Register Reference : 91A/0446

Development : Revised development of 4½ houses on 5.6 acre site of previously approved developments (O.P.ref.no. 88A/0014, appro.ref no.89A/0367) and relocation of entrance to existing house on adjoining site

LOCATION : "Springvale" Edmondstown Rd. Ballyboden

Report of the Dublin Planning Officer, dated 3 October 1991

PLAN B

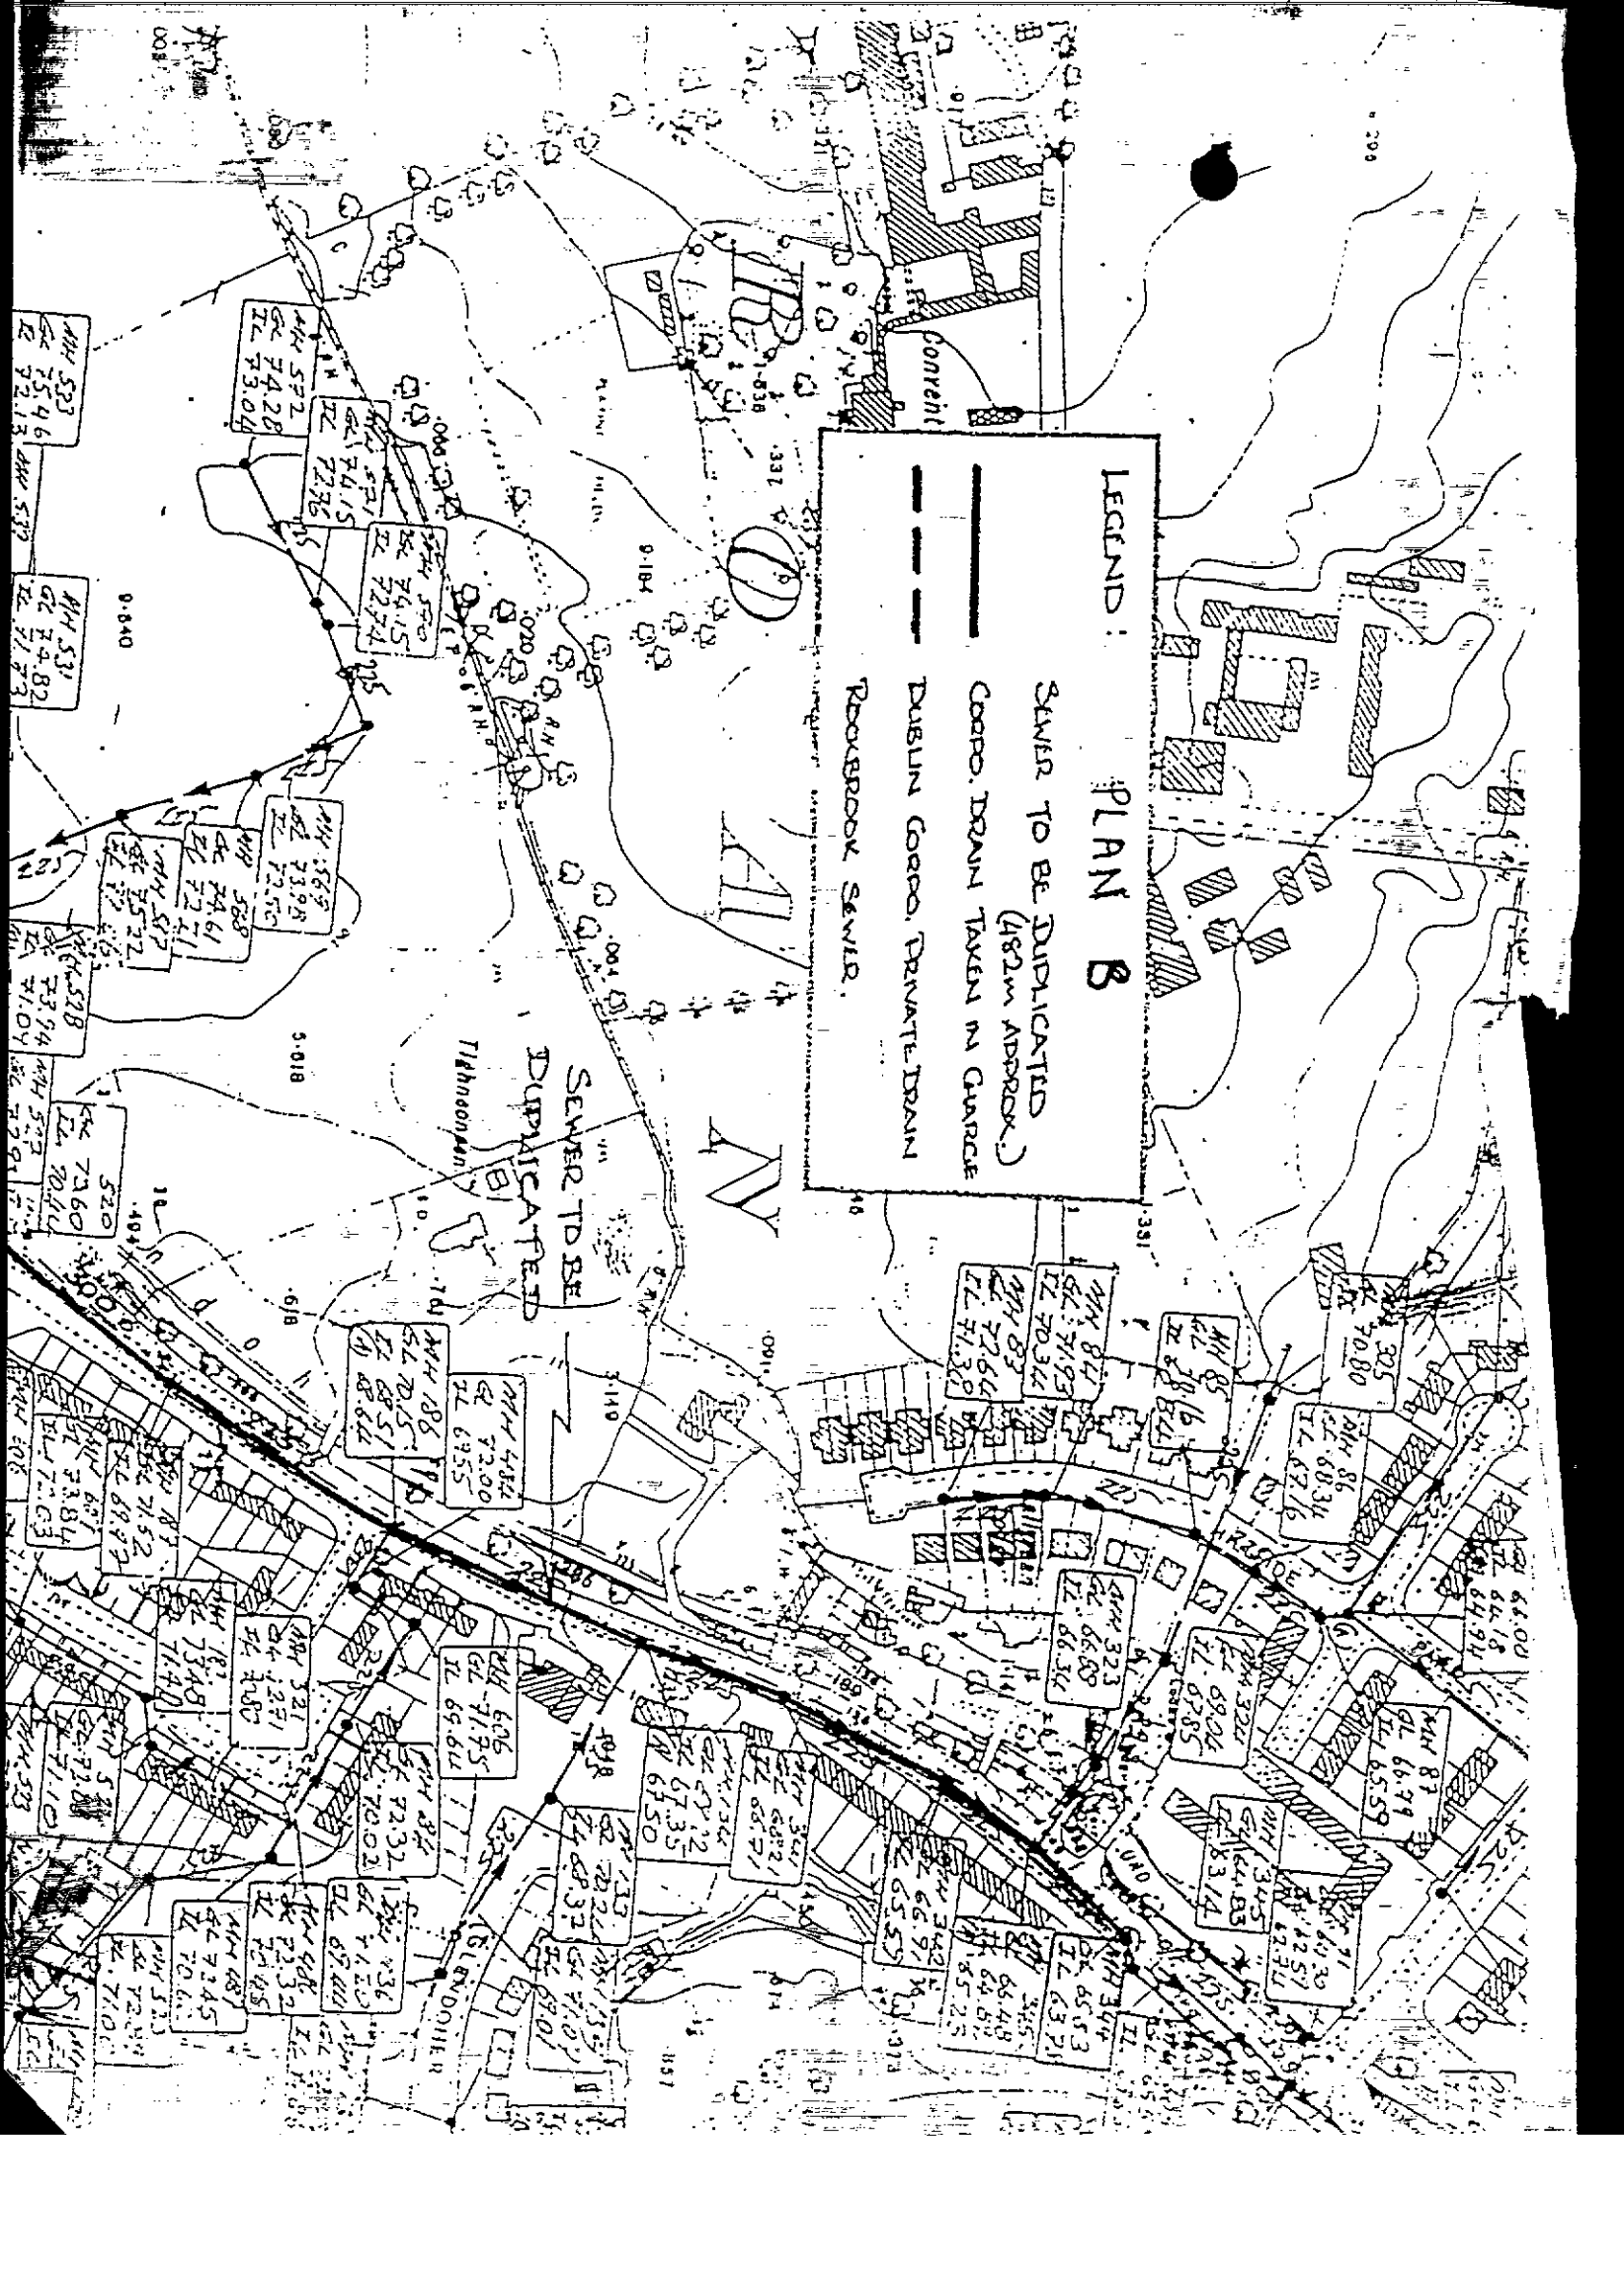
SEWER TO BE DUPLICATED
(482M APPROX.)

DETAILS TO BAY WINDOW
DRG NO.s 579/44/1-4

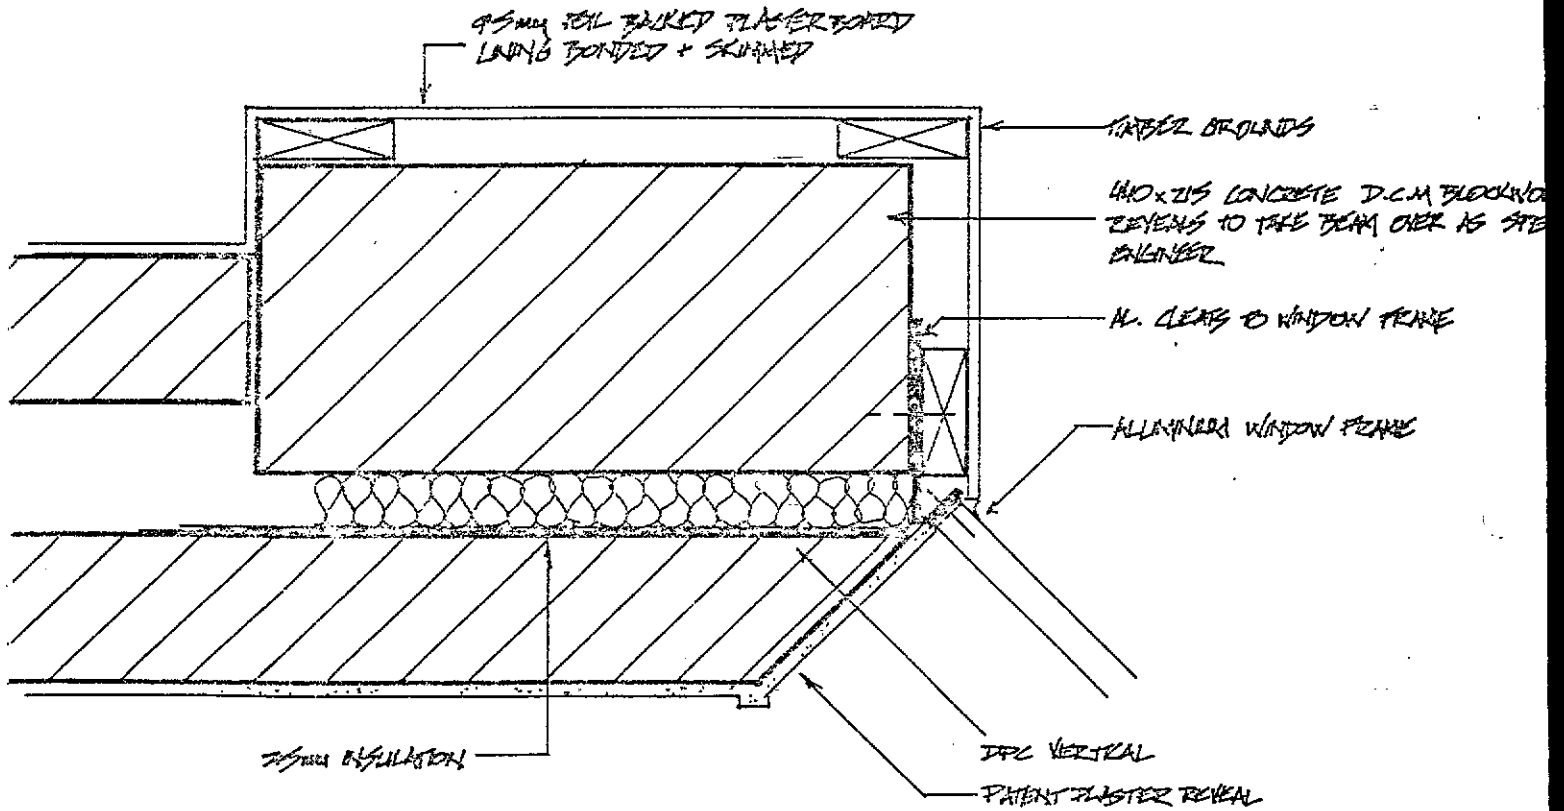
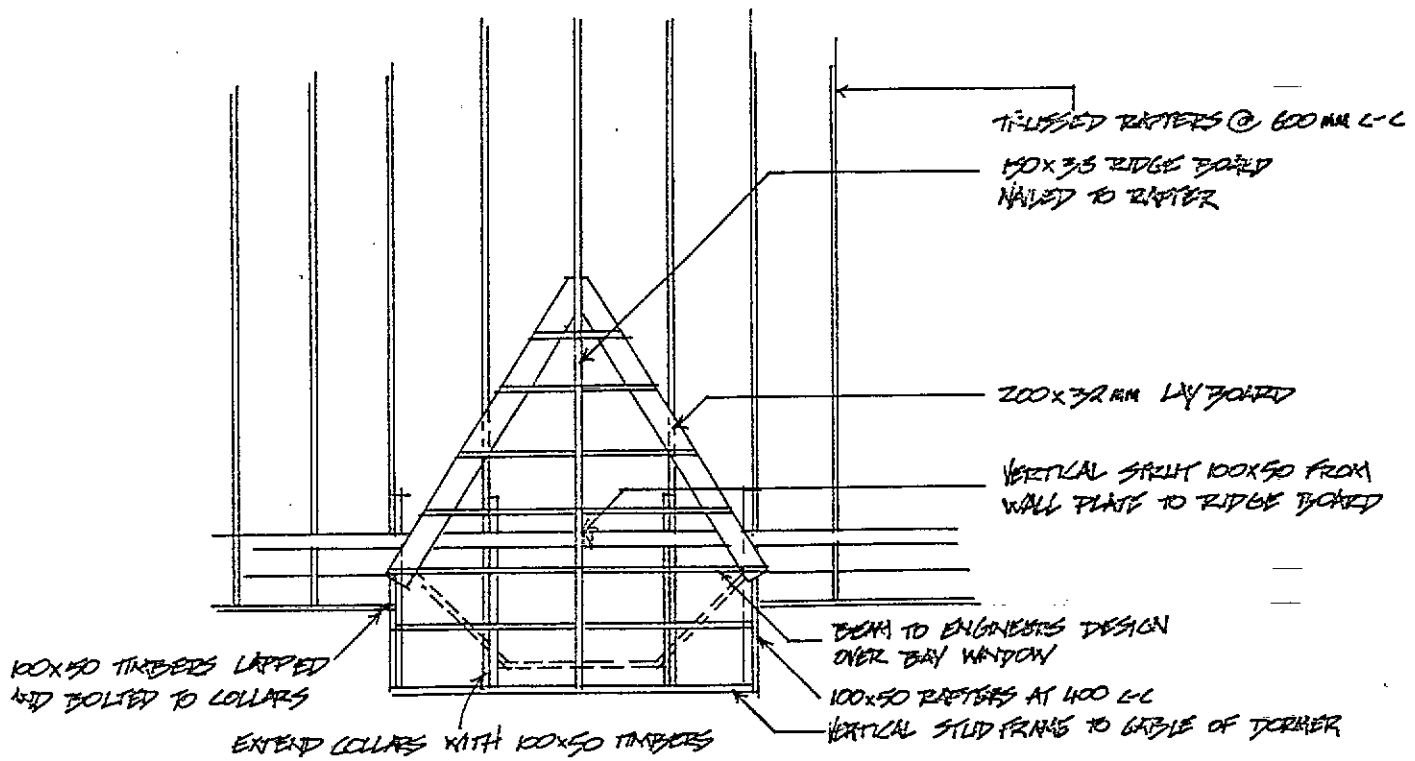
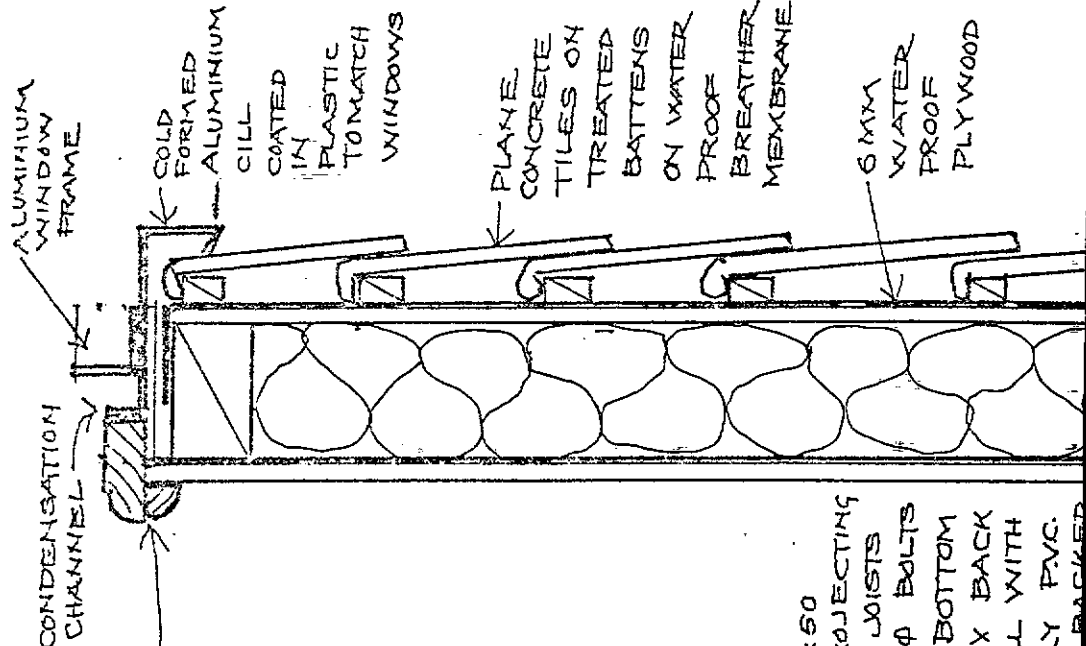
- (1) Revised copies of drawings 579/42A and 43A which illustrate the house type to be constructed with further information on the bay windows.
